Gatwick Airport Northern Runway Project

Consultation Report Second Addendum

Application Document Ref: 10.48

Table 6: Environment Agency’s Deadline 5 Response [\[REP5-090\]](#)

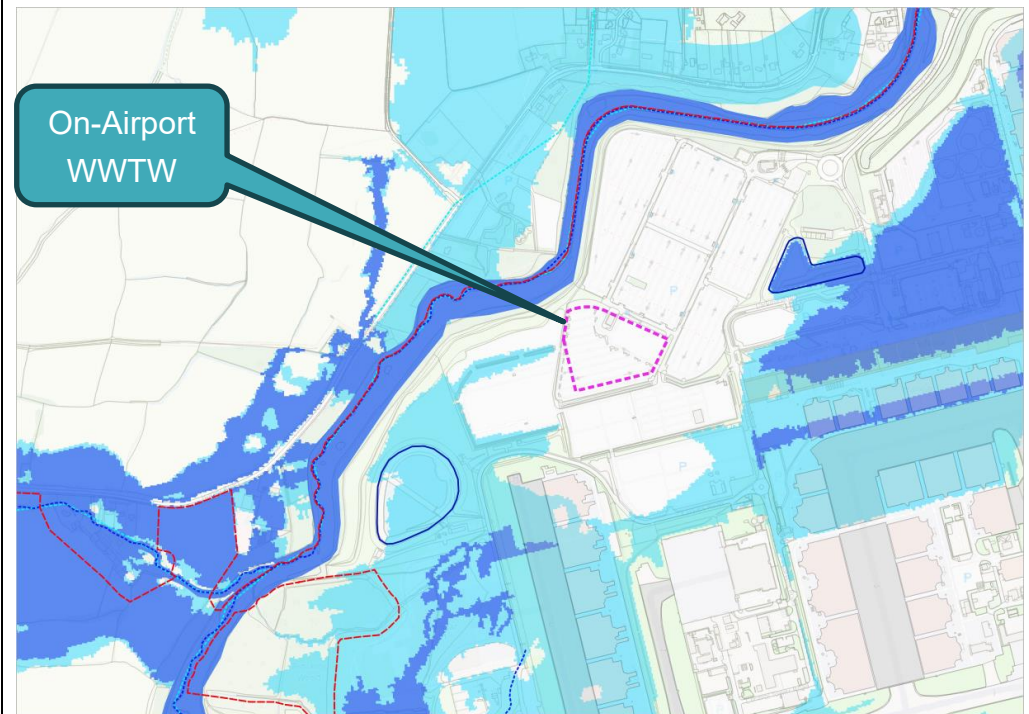
We will ask the applicant to confirm whether:

- The movement of flows from the catchment of Horley WWTW to Crawley WWTW will have any impact on onwards flows to the river catchment(s) and if the volume of flows be likely to have any impact on flood peaks in different rivers.

The On-airport WWTW is located outside the Environment Agency’s published Flood Zones 2 (light blue in the figure below) and 3 dark blue).
